To: T10 Technical Committee  
From: Rob Elliott, HP (elliott@hp.com)  
Date: 2 July 2003  
Subject: 03-240r0 SAS-1.1 Internal wide connector and cable

A 4-wide internal cable and connector solution is being designed for connecting controllers (e.g. PCI cards) to backplanes. It is intended to be used in place of: 4 SATA host connectors (on the controller) to 4 separate SATA cables to 4 SATA host connectors (on the backplane). This cable/connector is being proposed for both SATA II and SAS.

**Figure 2 — Internal wide cable environment**

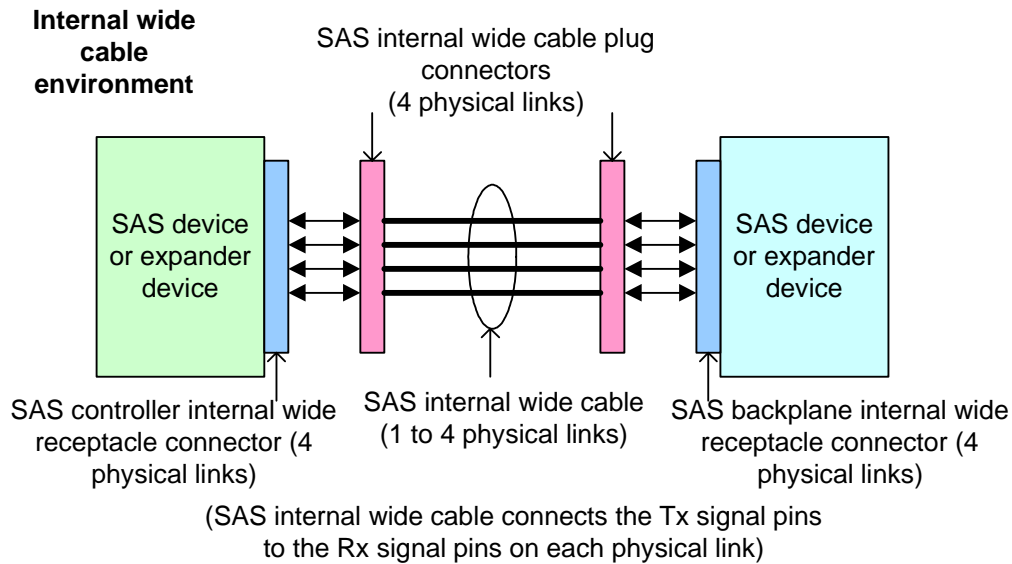
Figure 2 shows the internal wide cable environment.

The internal wide connectors have different pinouts for the controller side and the backplane side so one side's Tx signals are attached to the other side's Rx signals. Two controllers may also be attached together, provided all four physical links are used, since one side's physical link 0 is attached to the other side's physical link 3.

The internal wide connector contains 4 vendor-specific sideband signals which are crossed when attaching a controller to a backplane but are not crossed when attaching a controller to a controller.

**Figure 3 — SAS internal wide cable attaching controller to controller**

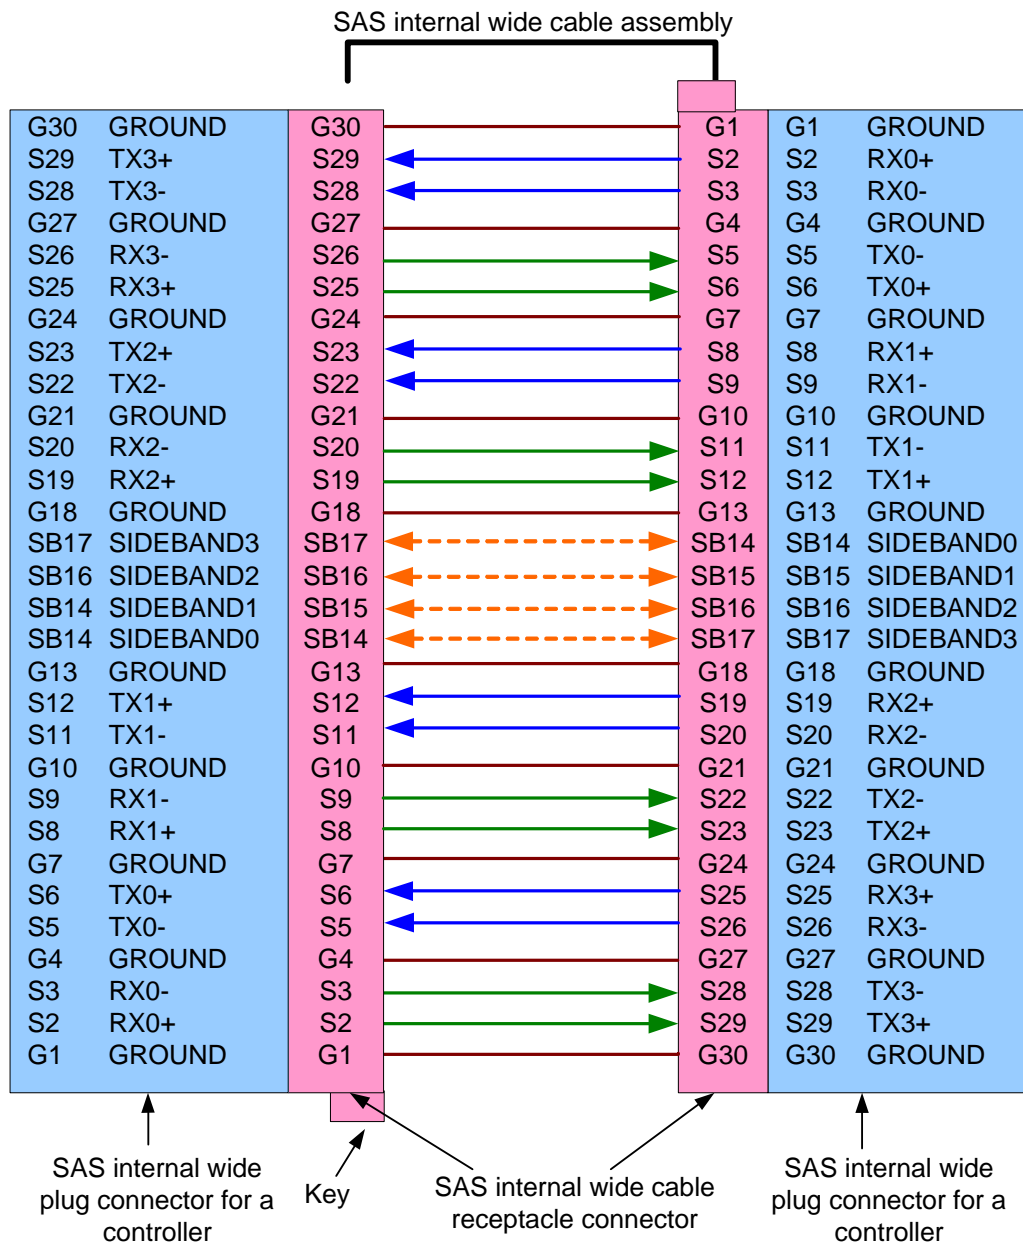
Figure 3 shows the SAS internal wide cable attaching two controllers.

NOTE 1 - For controller to controller applications, all four physical links should be used, because one side's physical link 0 is the other side's physical link 3. If both sides just used physical link 0, they would not communicate. The sideband signals are also crossed.

Figure 4 — SAS internal wide cable attaching controller to backplane

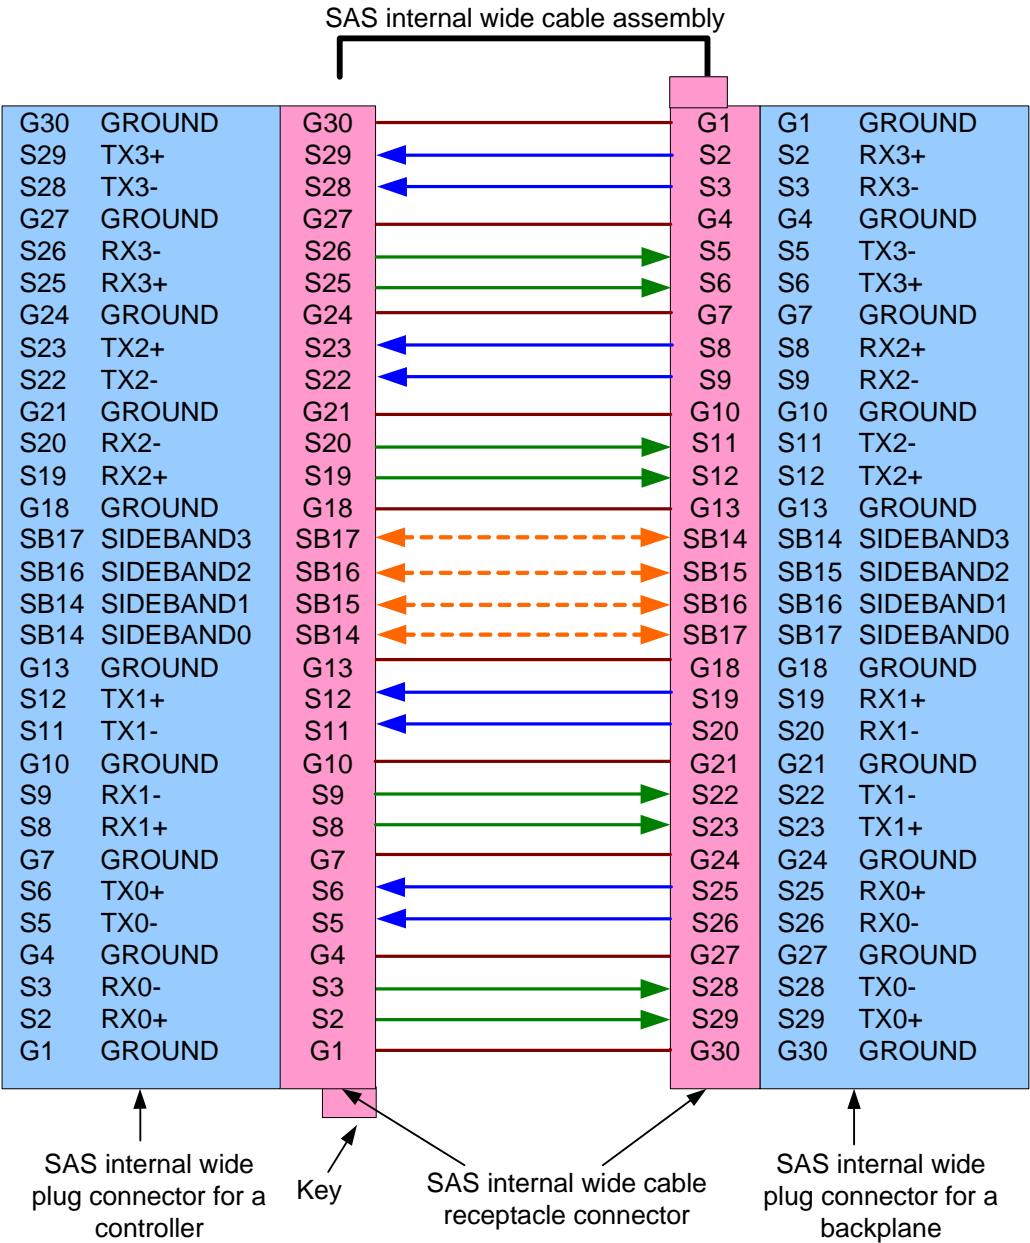
Figure 4 shows the SAS internal wide cable being used to attach a controller to a backplane.

NOTE 2 - For controller to backplane applications, up to four physical links may be used. The sideband signals are not crossed.
